IFB SA 2407 Belmont Sewage Pumping Station Replacement

**Addendum #4**

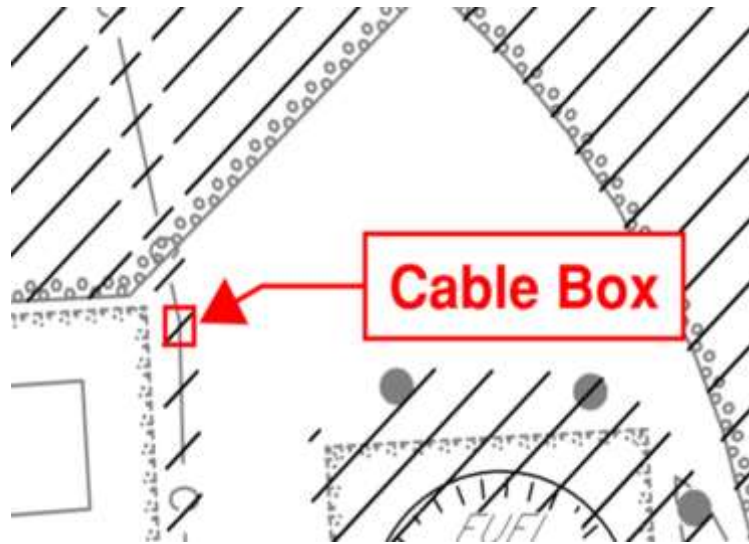
7. **Question:** Is any fire alarm required? There is no spec for it, but a note on the panel schedule drawings (E303 and E304) mentions a fire alarm control panel, which does not appear on the panel schedules or on the drawings.

**Response:** A fire alarm and fire alarm control panel are not required.

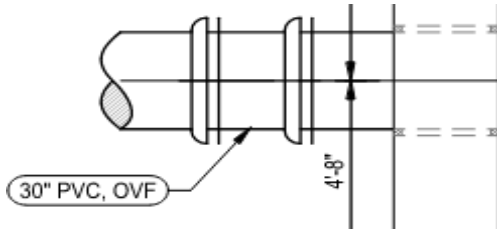
Please clarify that the Owner accepts generator status of all known and unknown pre-existing hazardous material and will sign transportation manifests as such whether shown in the documents or not, to be removed under this contract.

**Response:** The Contractor is responsible for demolition, transportation, and off-loading the generator to the Owner's designated location. In addition, the Contractor shall empty the diesel fuel tank and dispose of old diesel fuel prior to transporting Generator and fuel tank..

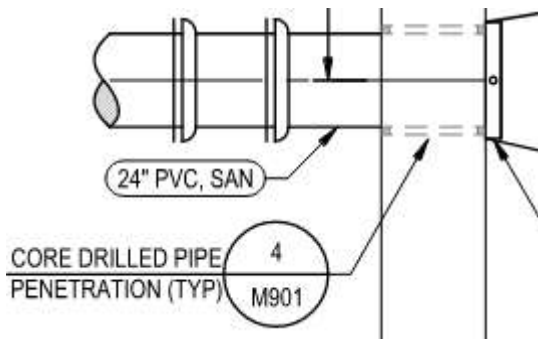
**12. Question:** Reference Dwg. C003 & M103; will mechanical joint, steel sleeve type couplings be required on the new 30" PVC Overflow piping outside the existing influent and pump station structures?

**Response:** No, however all pipes entering or leaving a structure shall have two joints within 4'-0" of pipe length from the wall of the structure per General Note O on Drawing G004.

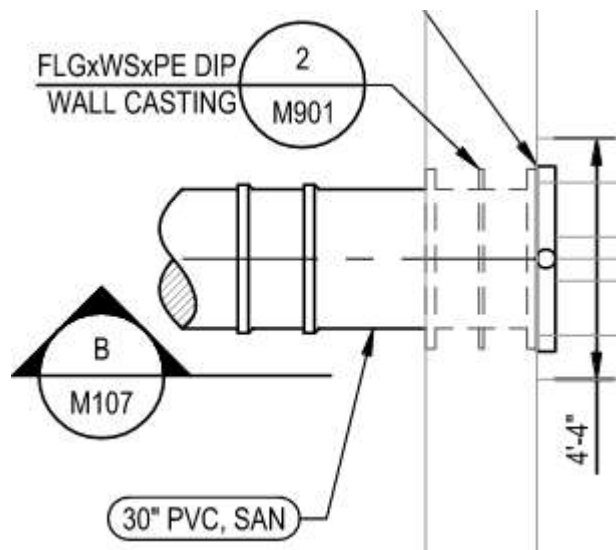
**13. Question:** Reference Dwg. C003 & M103; will a mechanical joint, steel sleeve type couplings be required on the new 24" PVC Sanitary piping outside the existing pump station structure?

**Response:** No, however all pipes entering or leaving a structure shall have two joints within 4'-0" of pipe length from the wall of the structure per General Note O on Drawing G004.

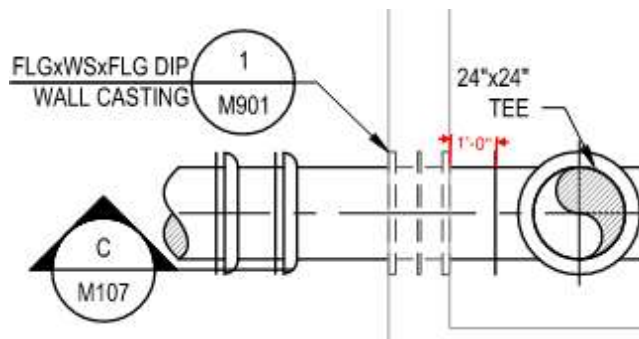
**14. Question:** Reference Dwg. C003, M105, & M107 - DETAIL B; will a mechanical joint, steel sleeve type couplings be required on the new 30" PVC Sanitary piping outside the NEW pump station structure?

**Response:** 30” PVC sanitary sewer shall be connected to the wet well using Detail 2 shown on Drawing M901, as referenced on Drawing M105. A DIP mechanical joint solid sleeve shall be used to connect from the 30” PVC pipe to the 30” DIP pipe connecting to the wall casting, as shown on the detail. Reference to Detail 1 on Drawing M107 Section B is incorrect, and should refer to Detail 2 on Drawing M901. Refer to Changes to Contract Drawings.

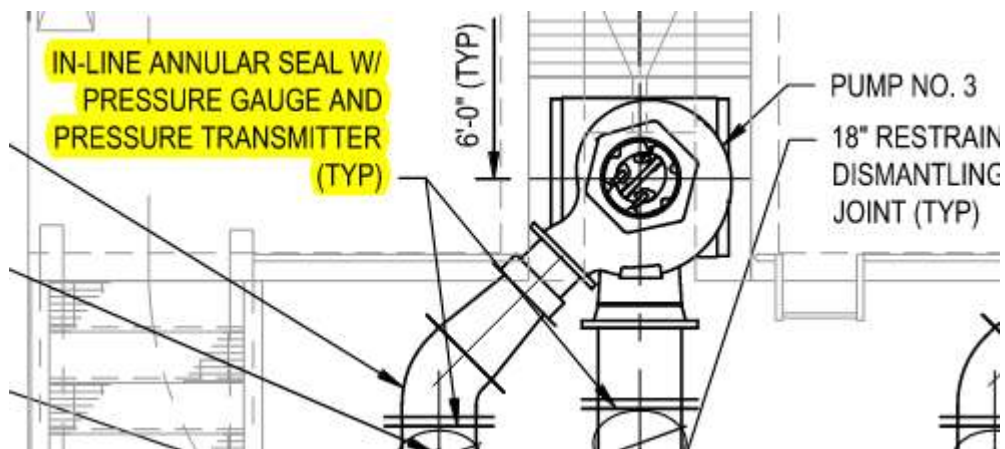
**15. Question:** Reference Dwg. C003, M105, & M107 - DETAIL C; will a mechanical joint, steel sleeve type couplings be required on the new 24” DIP force main piping outside the NEW pump station structure?

**Response:** 24” DIP force main shall be connected to the pumping station using Detail 1 shown on Drawing M901, as referenced on Drawing M105 and Drawing M107 Section C. Two deflectable pipe joints shall be provided within the dimensions shown on the detail, which may be achieved using a DIP mechanical joint solid sleeve.

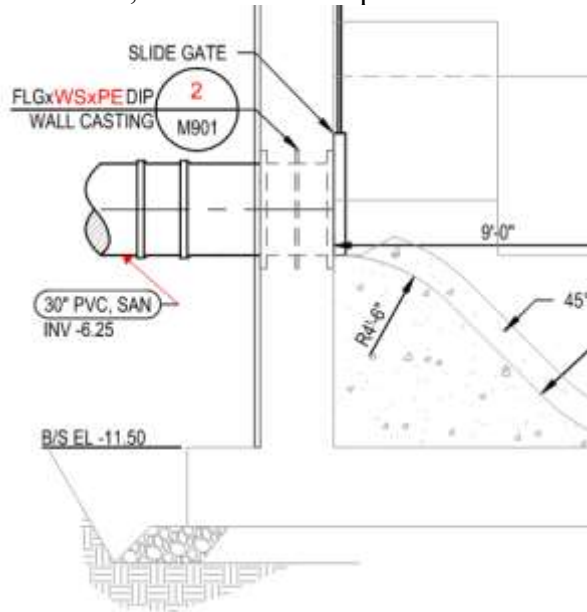
5. Drawing M107, Section B, 30” sanitary sewer, REPLACE wall casting detail callout with callout for Detail 2 on Drawing M901, “FLGxWSxPE DIP WALL CASTING” and MODIFY

“30” PVC, SAN” callout to point to left side of the two joints rather than the right side.

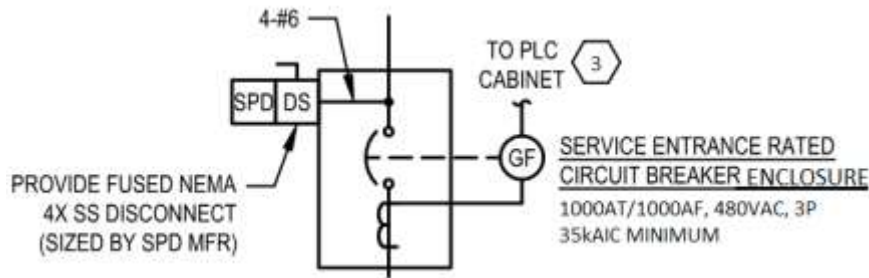
6. Drawing E002, Circuit Schedule, DELETE circuit PF-SE1. MODIFY “PF-SE2” to read “PF-SE”. MODIFY “CT CABINET” to read “UTILITY TRANSFORMER”.
7. Drawing E002, Service Entrance DB-SE Duct Bank Section, MODIFY “PF-SE2” to read “PF-SE”.
8. E002, Drawing Note 2, ADD “(CLX)” after “CLEANING MODE BLUE FLASHING LIGHT”.
9. E002, Electrical Site Plan, ADD extension of cable service to north wall of Sewage Pumping Station, with routing approximately where shown below. ADD callout to extension of cable “COORDINATE EXTENSION OF CABLE SERVICE WITH UTILITY.”

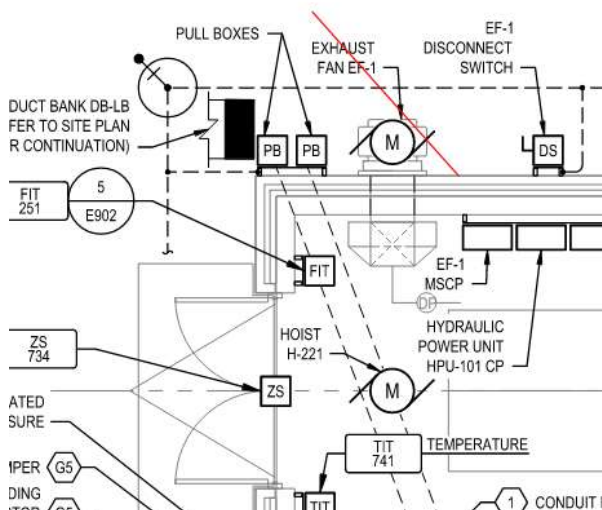
10. Drawing E003, Power Distribution One Line Diagram, MODIFY “PF-SE1” circuit tag to read “PF-SE” and “PF-SE2” circuit tag to read “PF-SE”.
11. Drawing E003, Power Distribution One Line Diagram, MODIFY portion of one-line depicting service entrance rated circuit breaker enclosure to what is indicated below:

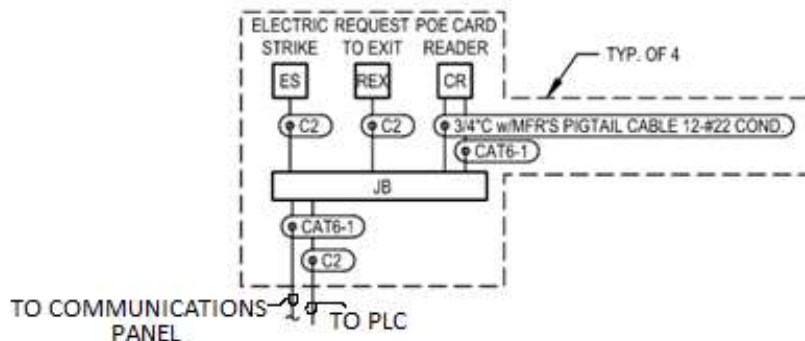
12. E101, Drawing Note 2, ADD “(CLX)” after “CLEANING MODE BLUE FLASHING LIGHT”.
13. E101, Drawing Note 3, MODIFY “COMBUSTIBLE GAS ALARM HORN AND ROTATING LIGHT: ALARM HORN AND ROTATING LIGHT” to read “COMBUSTIBLE GAS ALARM HORN AND FLASHING LIGHT (ALX): ALARM HORN AND FLASHING LIGHT”.
14. E101, Drawing Note 4, ADD “(AL)” after “VENTILATION ALARM HORN AND FLASHING LIGHT”.
15. E102, MODIFY “PLC CABINET” to read “PLC CONTROL PANEL”
16. E102, ADD cable service entry location, shown as C line type, on North side of building approximately where shown below.

17. Drawing E102, ADD request to exit (REX) adjacent to door 301 and door 300A. ADD card reader adjacent to door 300A.

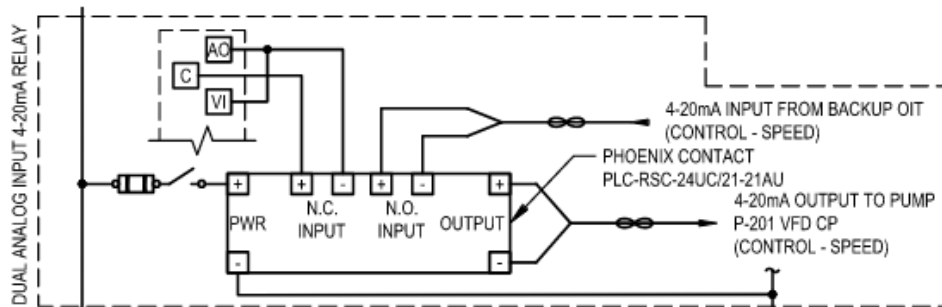
25. E401, ADD red flashing alarm light, type AL, in parallel to panel mounted horn.
26. Drawing E401, MODIFY depiction of hatch switch contacts to be normally closed (N.C.).
27. Drawing E401, ADD note for Backup OIT wiring “TYP. For 2”.
28. Drawing E401, MODIFY “AI TO BOTH PLC AND BACKUP OIT CONTROLLER WITH DUAL OUTPUT 4-20mA SIGNAL ISOLATOR” to read “AI TO PLC AND BACKUP OIT CONTROLLERS WITH QUAD OUTPUT 4-20mA SIGNAL RETRANSMITTER”.  
MODIFY dual output 4-20mA Signal Isolator to a quad output 4-20mA signal retransmitter.  
ADD callout for signal retransmitter “MICRON METERS QLS-2 OR EQUAL.”
29. Drawing E401, ADD dual analog output 4-20mA signal isolator for “Speed – Indication” to Backup OIT and PLC from VFD CP.
